HISTORIC AND DESIGN REVIEW COMMISSION

December 05, 2018

HDRC CASE NO: 2018-575
ADDRESS: 414 NAVARRO ST
LEGAL DESCRIPTION: NCB 416 BLK 23 LOT 21/2 ARB A10 & A11
ZONING: D, HS, RIO-3
CITY COUNCIL DIST.: 1
LANDMARK: Nix Professional Building
APPLICANT: Leswee Wong, AIA
OWNER: Nix Health Care System
TYPE OF WORK: Removal of two windows and the installation of metal louvers
APPLICATION RECEIVED: November 15, 2018
60-DAY REVIEW: January 15, 2018
REQUEST:

The applicant is requesting a Certificate of Appropriateness for approval to remove two existing windows on the seventeenth floor and install metal louvers for mechanical supply air and exhaust air. The proposed metal louvers will be painted to match the existing windows as well as the existing louvers. These modifications will occur on the Navarro elevation.

BUILDING
PHOTOS

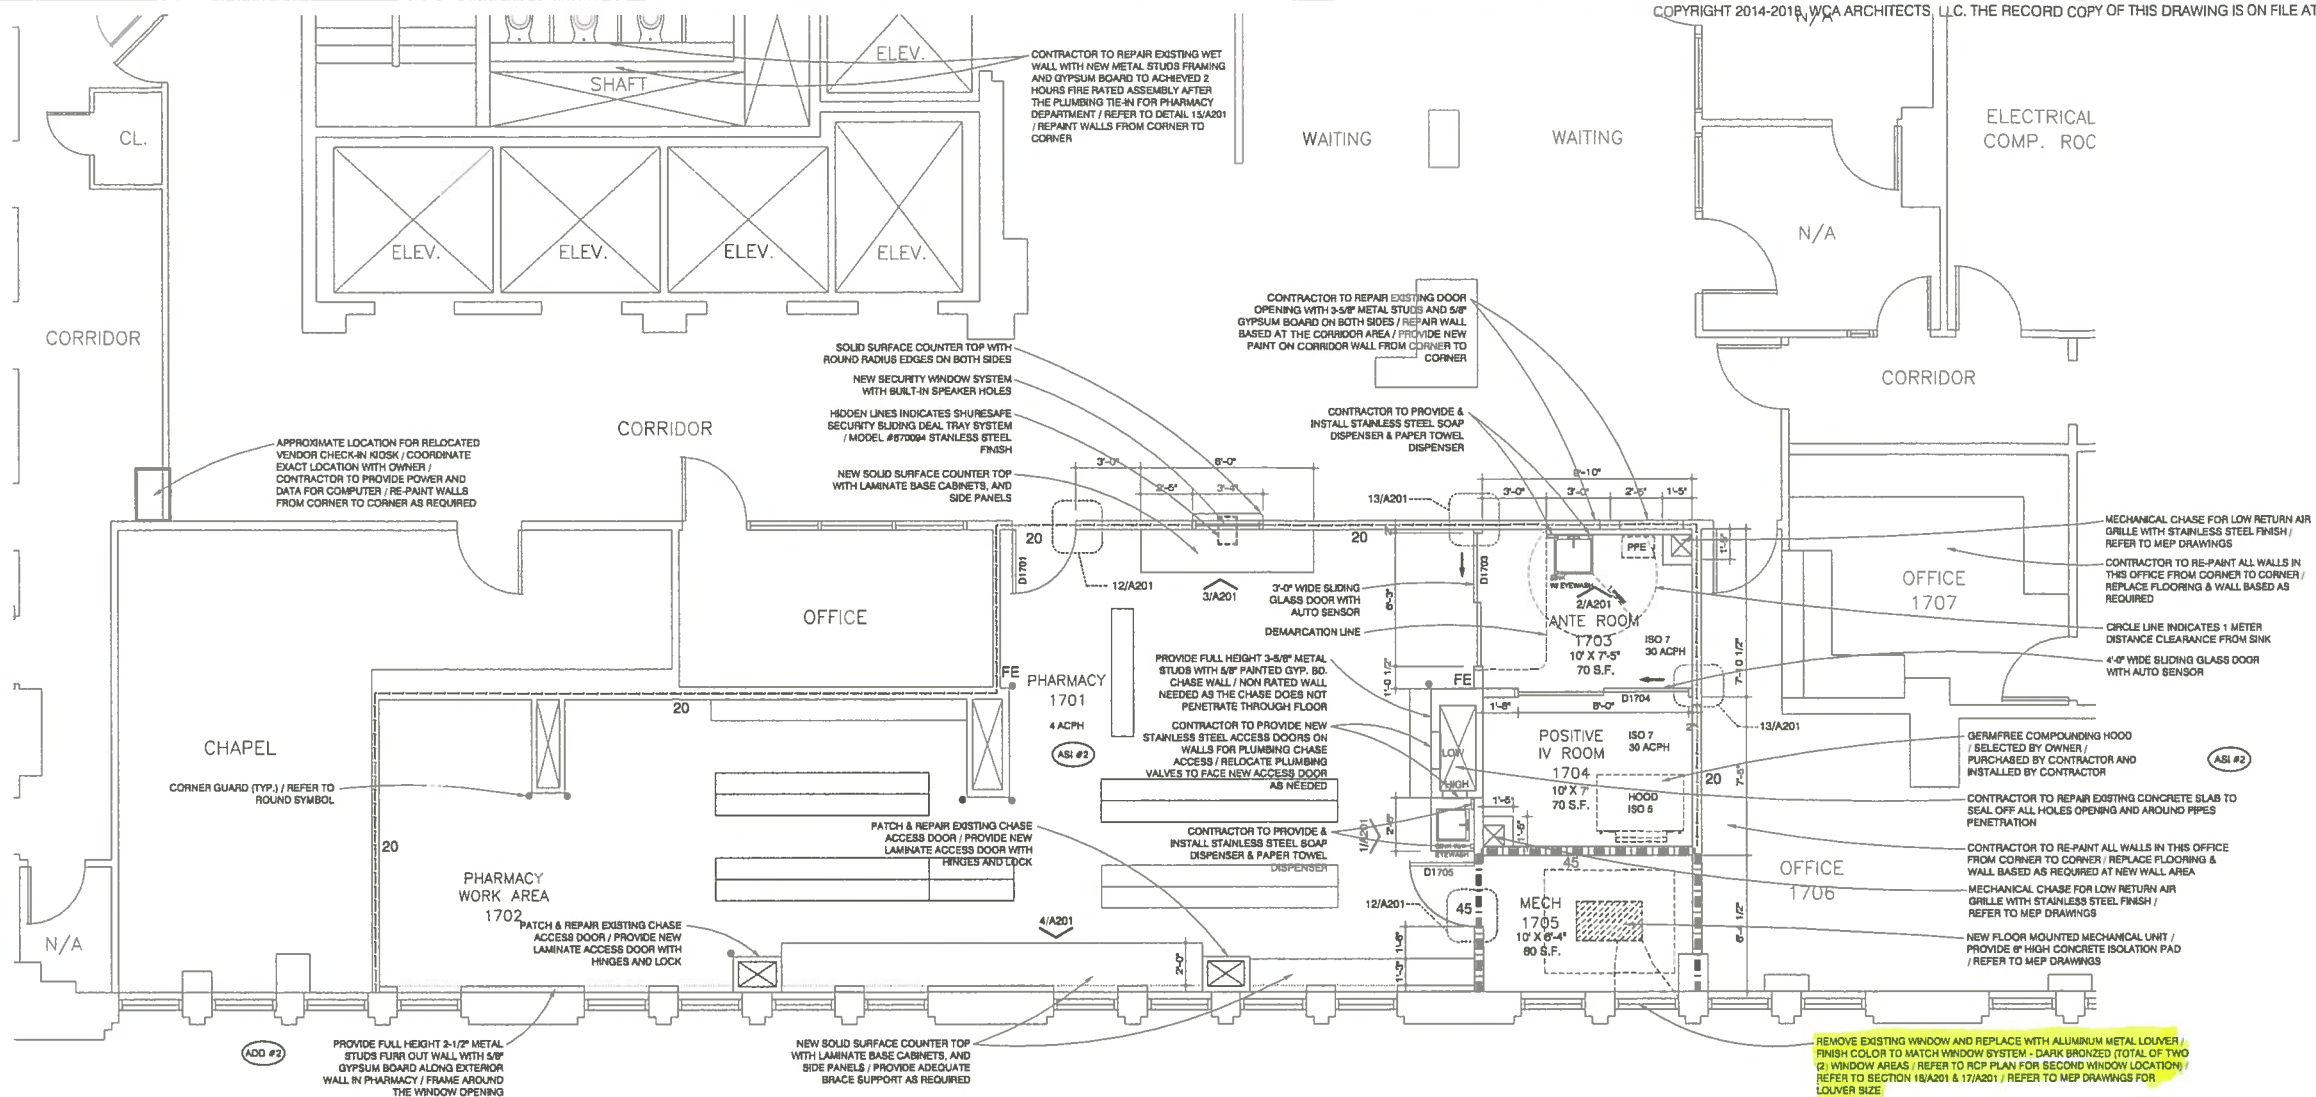
windows on the seventeenth floor and install metal louvers for mechanical supply air and exhaust air. The proposed metal louvers will be painted to match the existing windows as well as the existing louvers. These modifications will occur on the Navarro elevation. The Guidelines for Exterior Maintenance and Alterations 10.A.i. notes that character defining features should be preserved. Additionally, the Guidelines note that original window openings should be preserved and that new façade elements that alter or destroy the historic building character should not be introduced. Staff finds that the removal of the existing windows and the installation of metal louvers for mechanical purposes may be appropriate provided that the sizes of the two openings are not modified and that the existing windows are stored on site.

Staff recommends approval based on findings a and b with the following stipulations:

- i. That the existing window openings not be modified in size and that the removed windows be stored on site.
- ii. That the louvers match the existing windows and louvers in color and finish.
